UNITED STATES NUCLEAR REGULATORY COMMISSION'S ADVISORY
COMMITTEE ON REACTOR SAFEGUARDS

Title: Advisory Committee on Reactor Safeguards
 ESBWR Subcommittee: OPEN SESSION

Date: Wednesday, October 21, 2009

14 Final items pertaining to this particular
15 topic, GEH has responded to RAI 21.6-12, which was on
16 the presentation agenda here. I will be covering GDCS
17 operation during LOCA, GDCS injection, line
18 integration, in-service testing of GDCS injection
19 lines, sources of non-condensable gases in those lines
20 and, actually, the calculations for GDCS flow. I will
21 summarize at the end there.

Sloping of Horizontal Runs

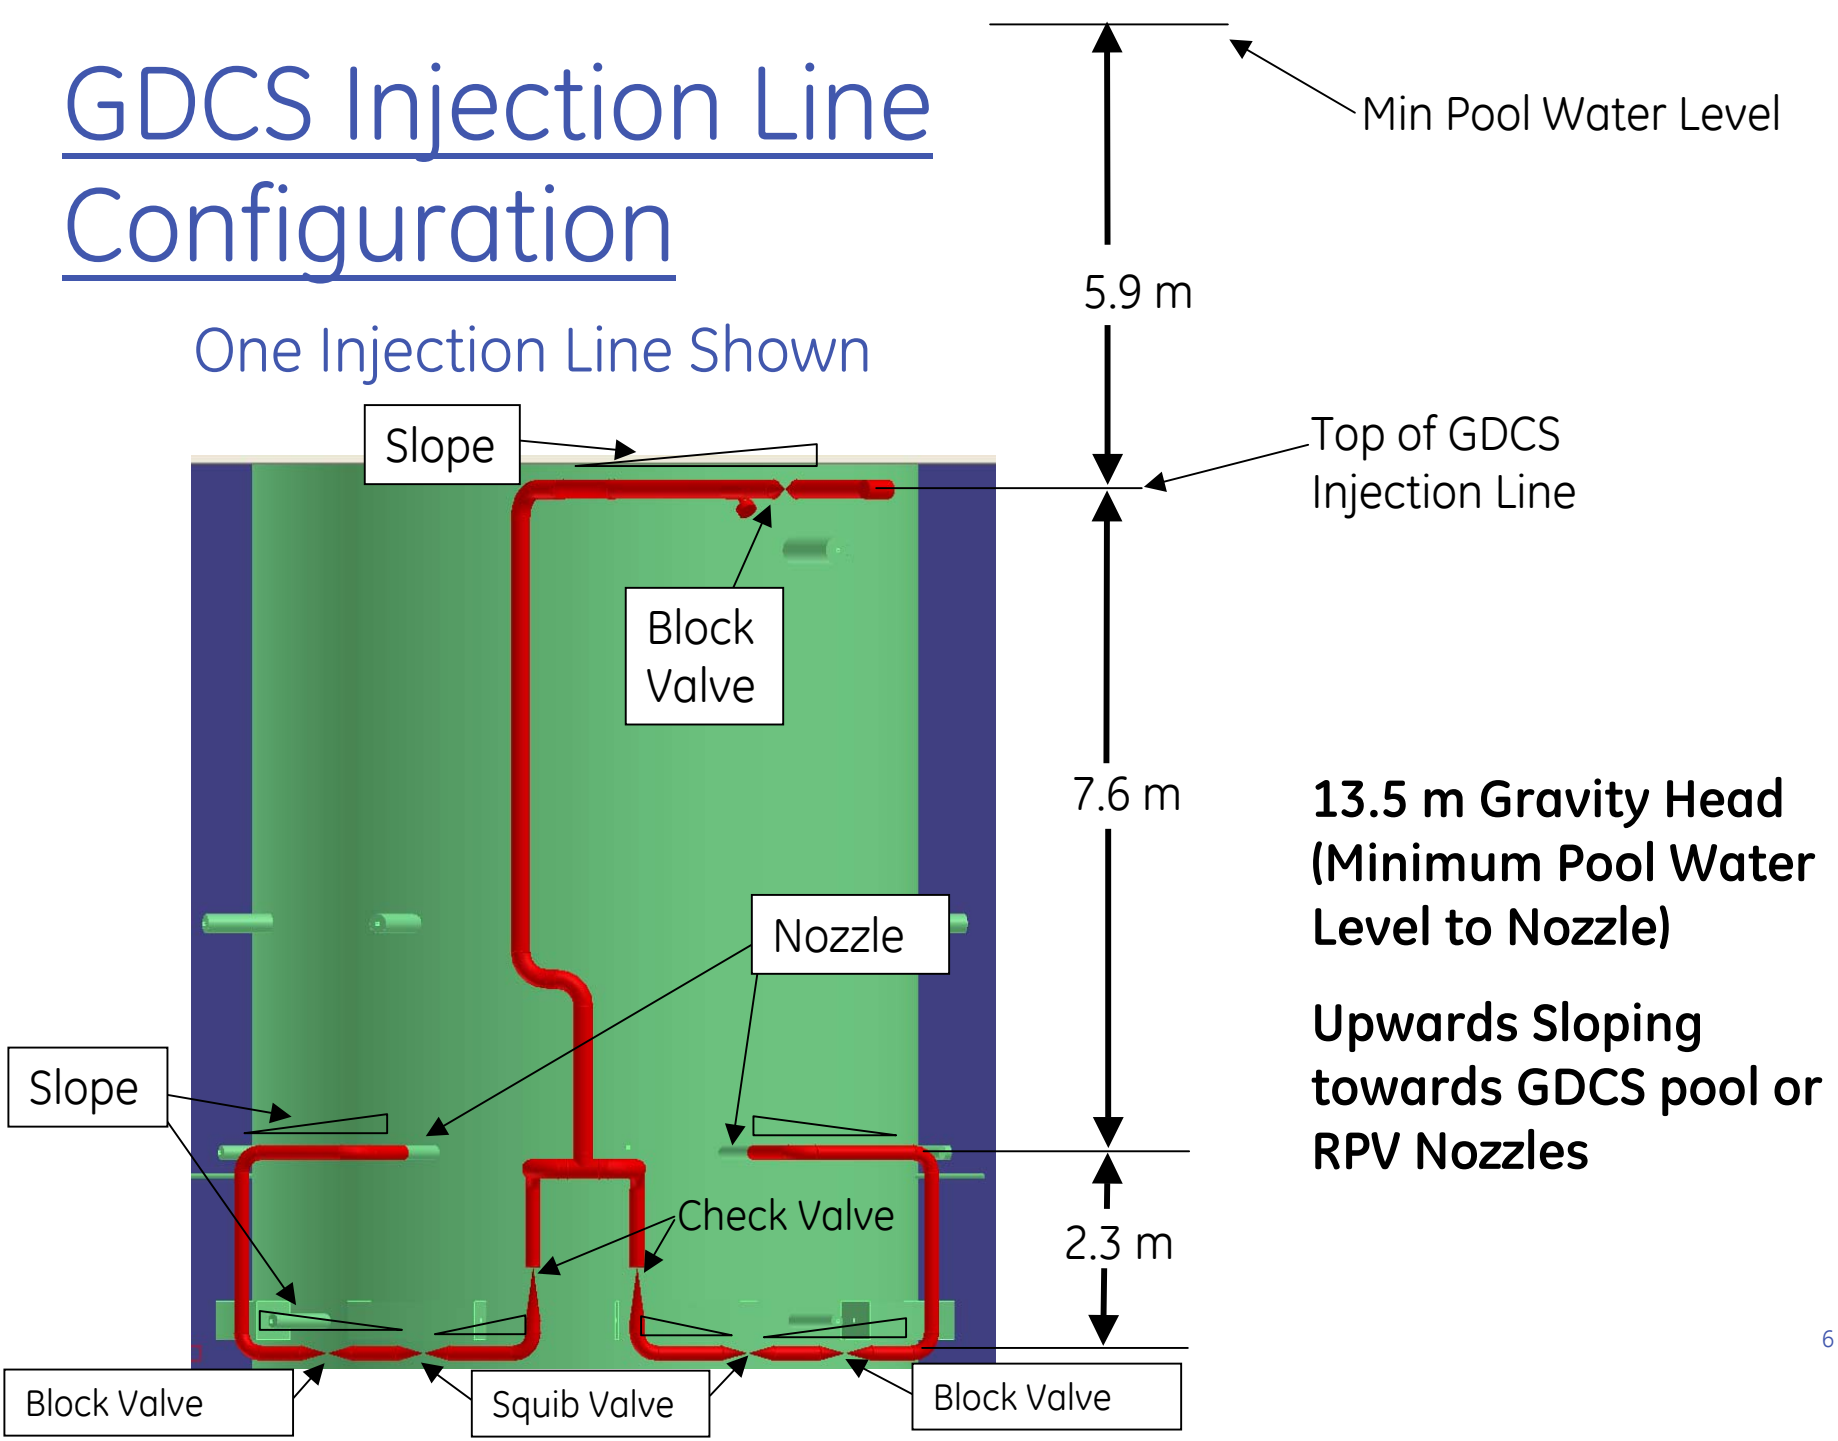
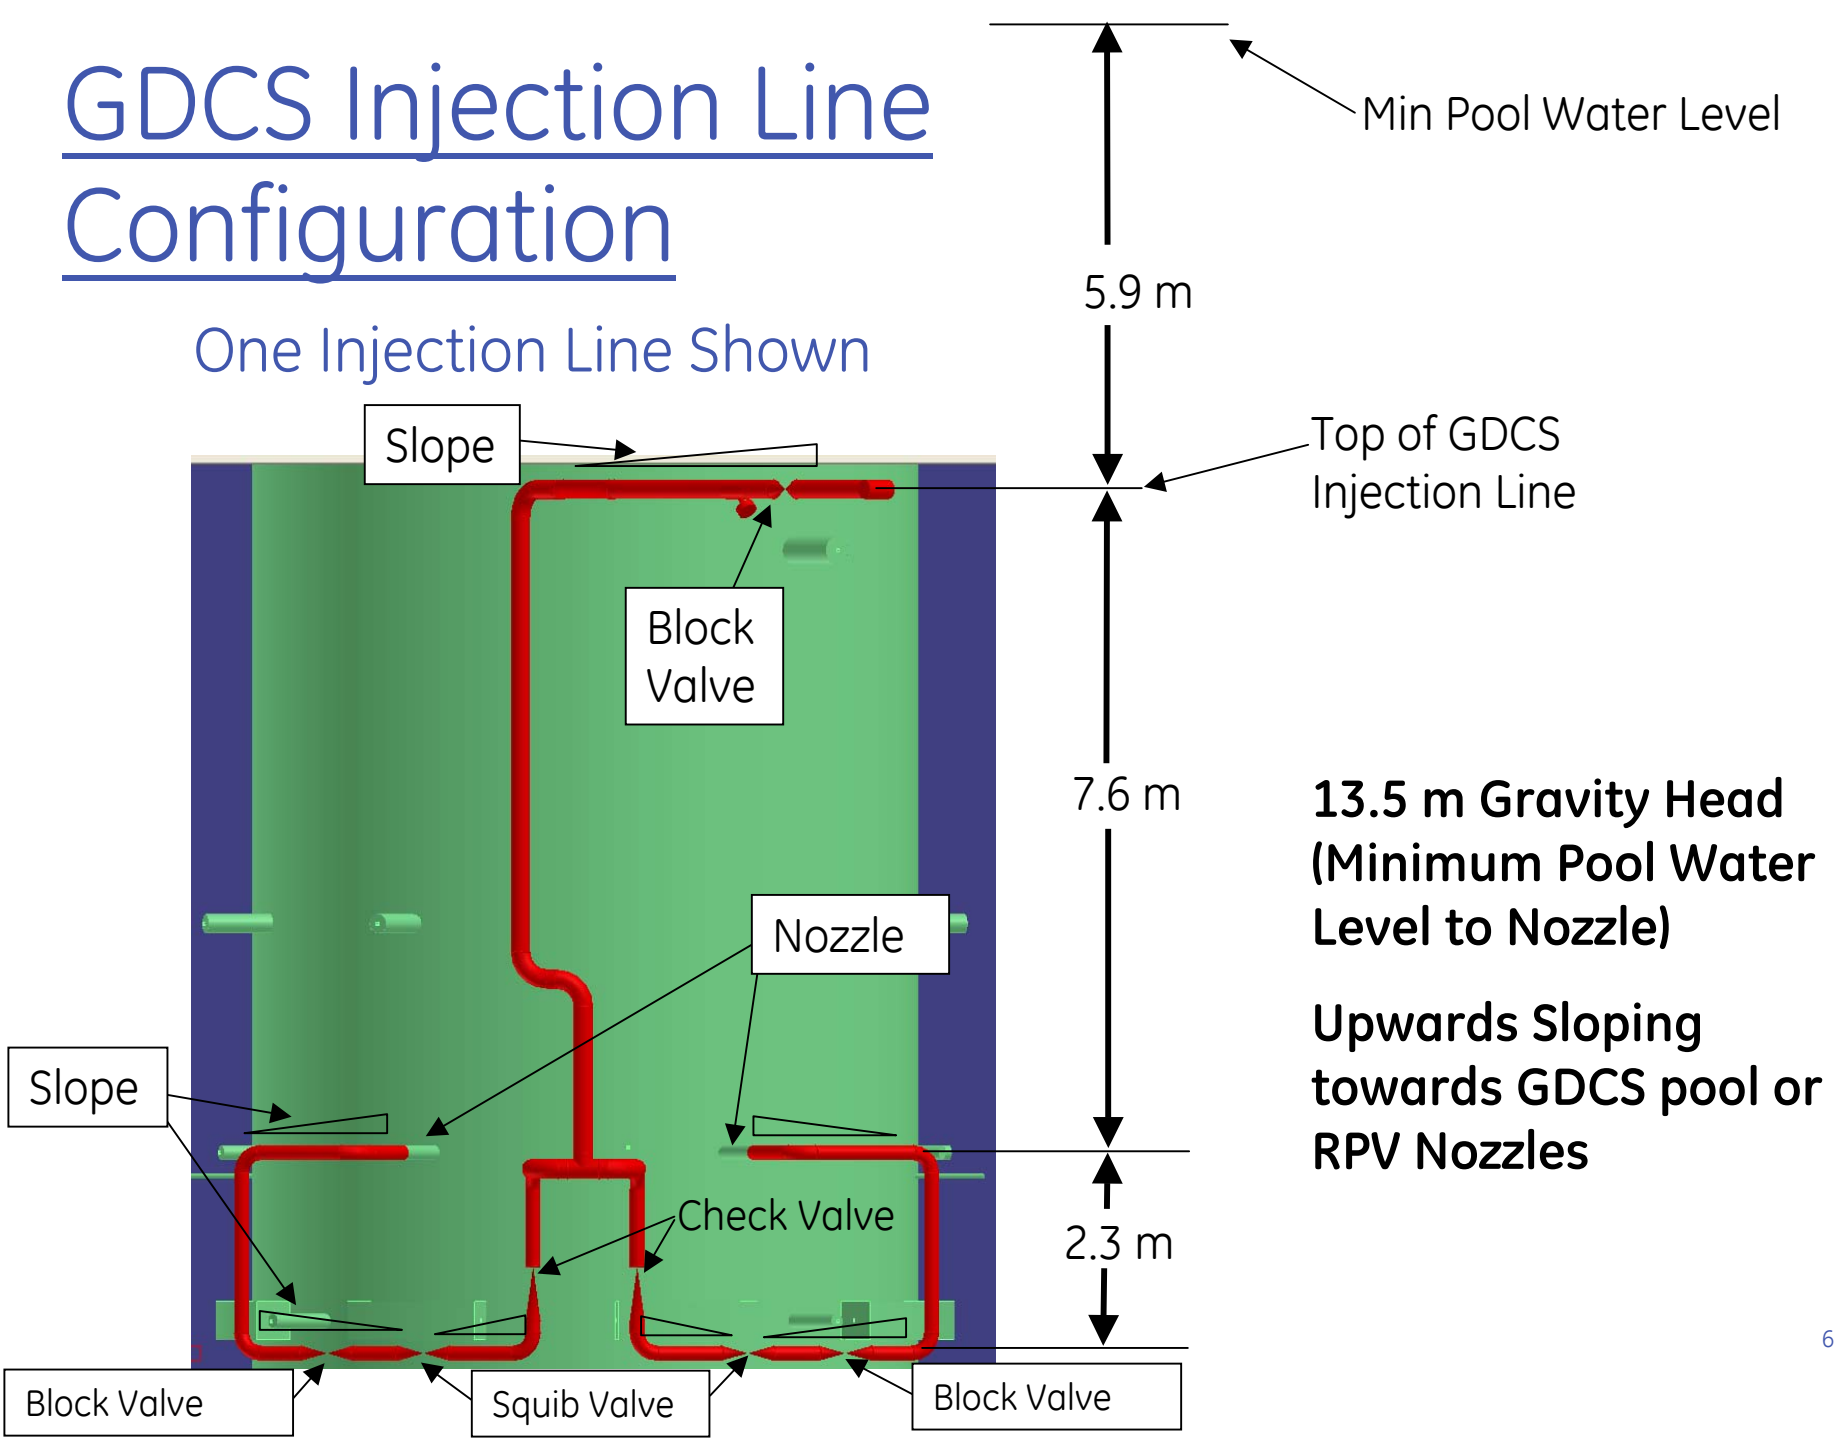
15 MEMBER BANERJEE: Can you go back to the
16 figure and show the sloping?

1 depiction, a 3D depiction, it is difficult to show
2 sloping, but the triangles here show the way. There's
3 the squib valve. Sloping is away from the squib
4 valve. So it is up. Of course, the vertical run, and
5 then, since this is downstream of the squib valve, you
6 have sloping up toward the nozzle.

17 CONSULTANT WALLIS: It doesn't show that
18 in the figure. I don't think that is correct.

2 CONSULTANT WALLIS: If it is so big, you
3 should really show it on the figure, because it is
4 misleading to show it --

14 MEMBER BANERJEE: That is not shown in
15 the figure.

- Upstream of Squib Valve – Sloped Upwards Towards GDCS Pools
- Downstream of Squib Valve – Sloped Upwards Towards RPV Nozzles

- Upstream of Squib Valve – Sloped Upwards Towards GDCS Pools
- Downstream of Squib Valve – Sloped Upwards Towards RPV Nozzles

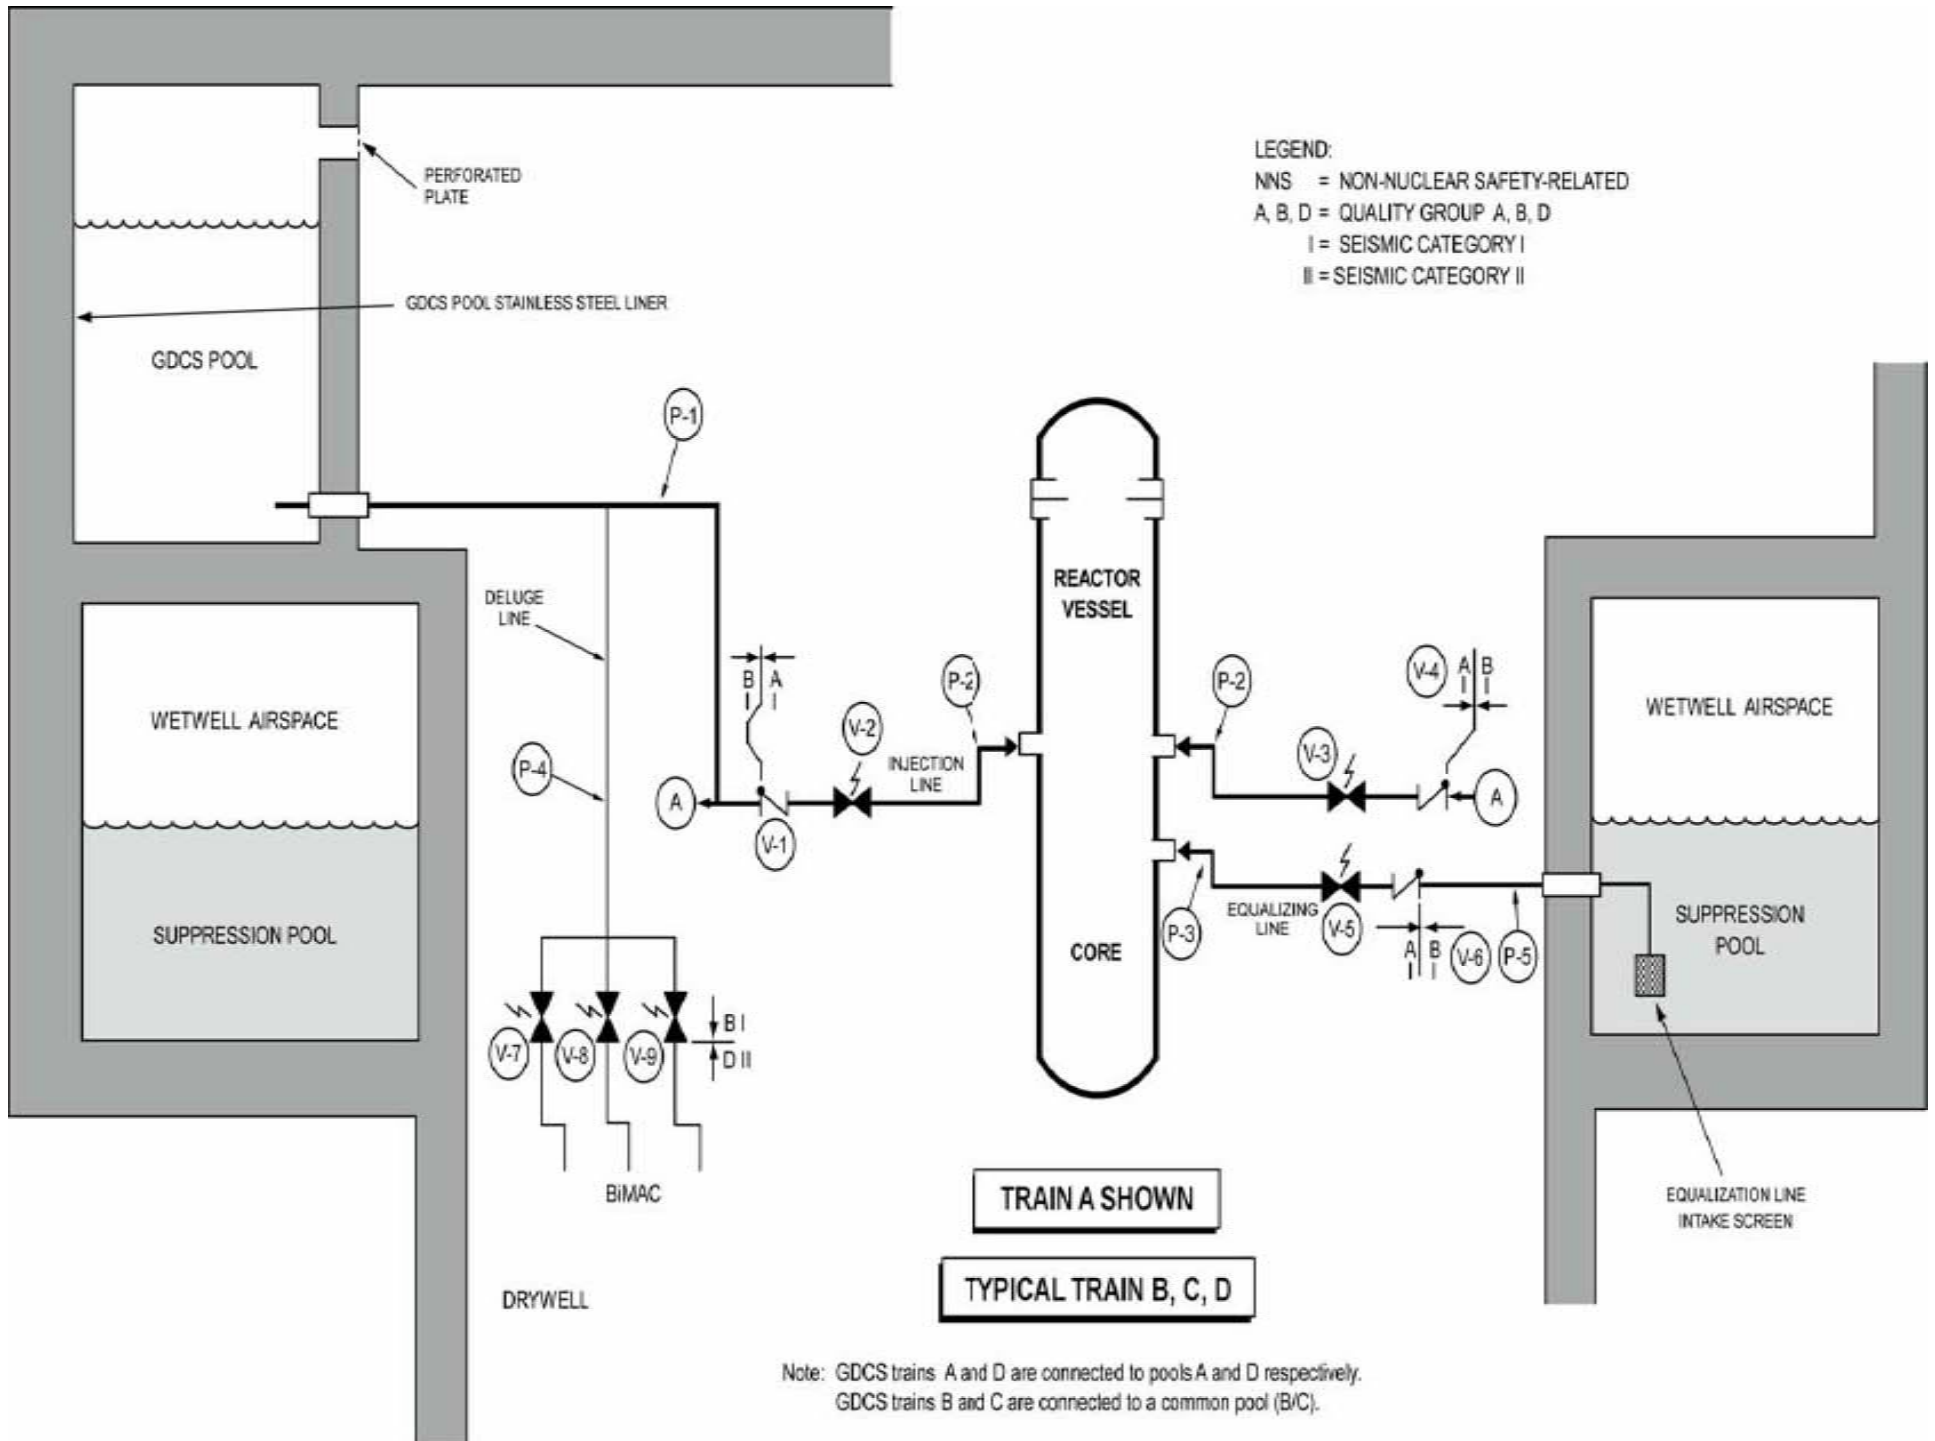
16 CONSULTANT WALLIS: This is another one of
17 these cases where the cartoon is very misleading. It
18 doesn't show the sloping-up of the lines.

2 MR. SCARBROUGH: Yes, these are, in fact,
3 the drawings that are in the tier one. They are just
4 sort of conceptual. But you're right, that's why, in
5 terms of we did ask for an RAI and received an
6 isometric drawing of it to get a better feel for it,
7 but you're exactly right, these are not clear.
